STAFF REPORT

File Number	PL 15-187	Contact	Steven Robertson, 218-730-5295	
Application Type	Variance, Side Yard Setback	Planning Commission Date	January 12, 2016	
Deadline for Action	Application Date	December 15, 2015	60 Days	February 13, 2016
	Date Extension Letter Mailed	December 18, 2015	120 Days	April 13, 2016
Location of Subject	3427 Lake Avenue South			
Applicant	Lake Avenue South LLC	Contact	Bill Brownell and Pat Brownell Sterner	
Agent	Mike Medlin	Contact		
Legal Description	Lots 313 and 315 Lower Duluth Lake Avenue, and Northerly 25 fet of Lot 316 Lower Duluth			
Site Visit Date	January 4, 2016	Sign Notice Date	December 28, 2015	
Neighbor Letter Date	December 18, 2015	Number of Letters Sent	29

The applicant is proposing to add a 12.8' by 10' kitchen addition to an existing single family home within the R-1 side yard setback.

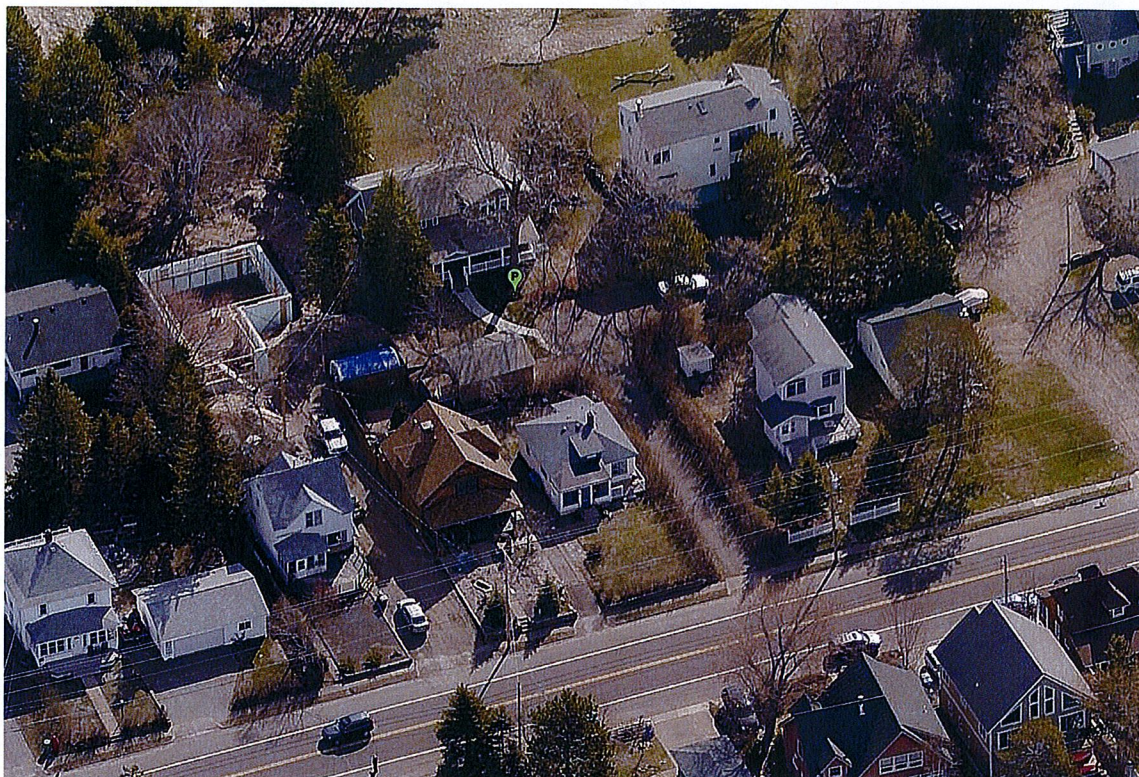
--Issue/Item for Review: The proposed addition would be 2 feet from the side lot line; the minimum side yard setback is 6 feet.

3D) The relief, if granted, may impair an adequate supply of light and air to adjacent property owners.

Based on the above findings, Staff recommends that Planning Commission deny the variance for the following reasons:

1) The application has not demonstrated that the requirements of the city's zoning code would result in practical difficulties to the property owner.

2) The application has not demonstrated that special circumstances or conditions exist on the property.

3) The application has not demonstrated that the relief is necessary for the continuing preservation and enjoyment of a substantial property right.

3427 S Lake Ave

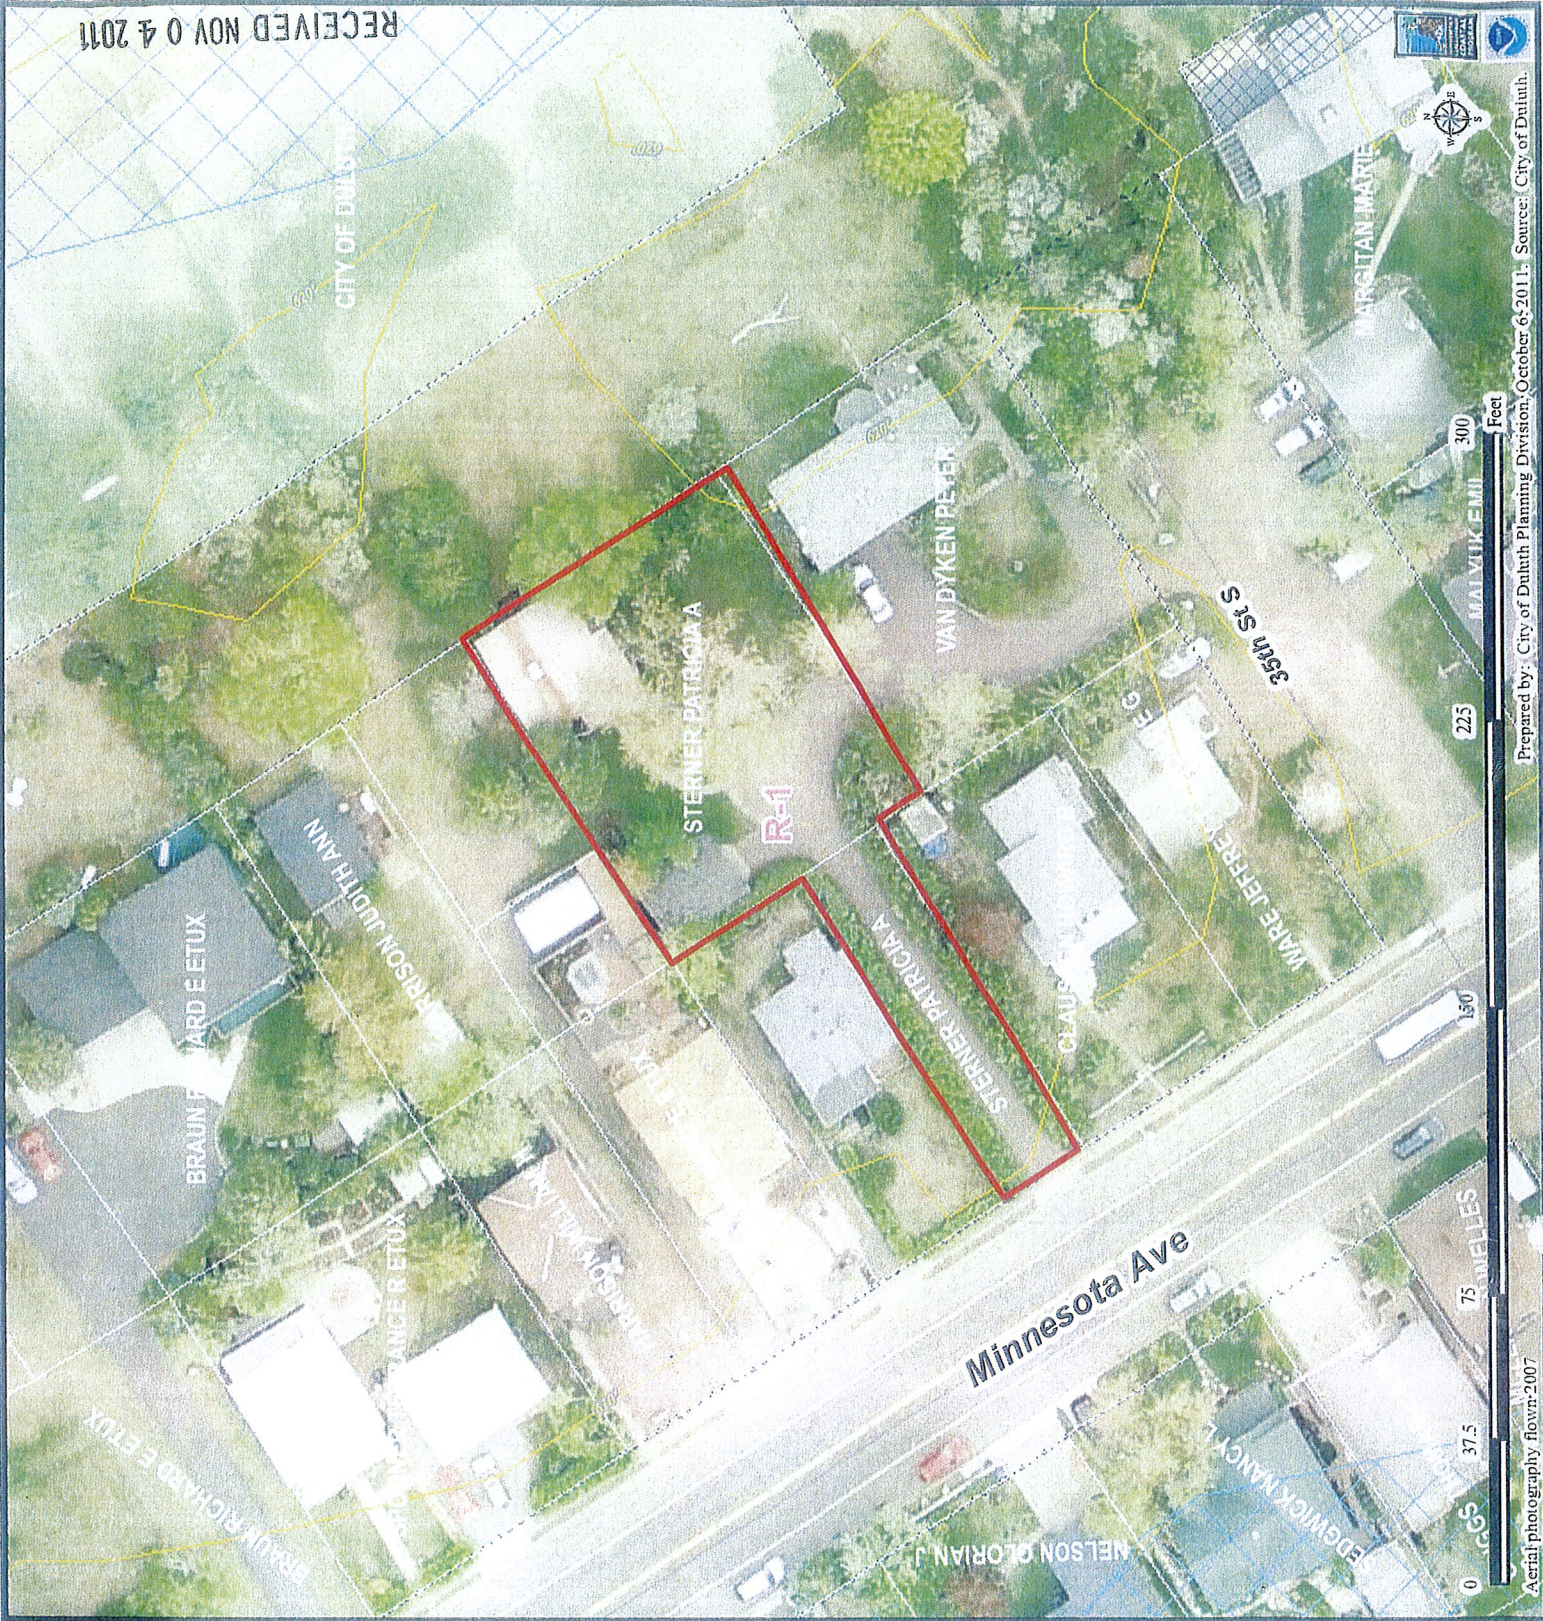
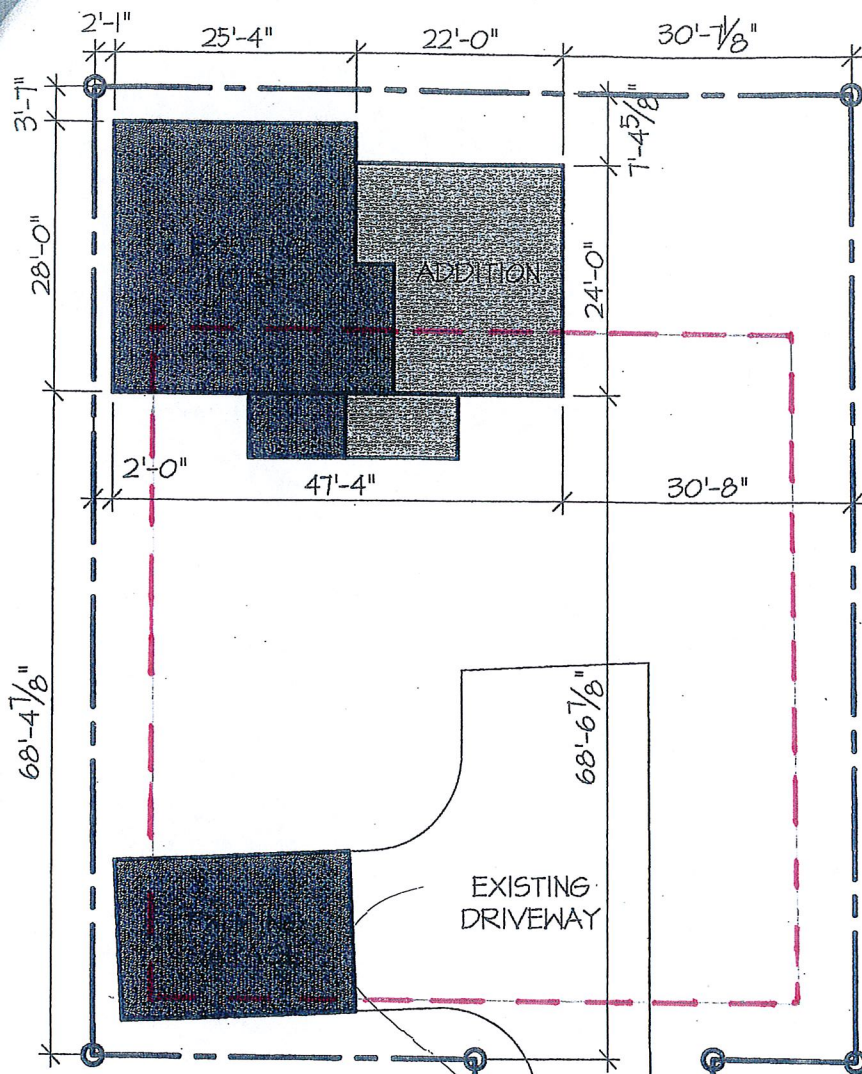
- 1.) The applicant's property is 80' wide by 100' deep with a 20' wide strip of land connecting it to Minnesota Avenue. It is improved with a 1,323 s.f. home and detached single-car garage. The attached site drawing shows in red dashed lines the building setbacks for this lot. The property is a size typical for Park Point. It is not exceptionally narrow, though 100' is shallower than most lots in the city.

Staff finds that the standard for variance has been met and, therefore, recommends the Planning Commission approve the requested variance because the applicant developed building plans based on the previous UDC and wasn't aware of the pending changes that would significantly affect the siting of the building addition, a situation beyond the control of the applicant. Reworking the building plans to comply with the amended UDC would present an undue hardship to the applicant and neither the essential character of the area nor the purpose and intent of the UDC or Comprehensive Plan will be compromised by granting the variance.
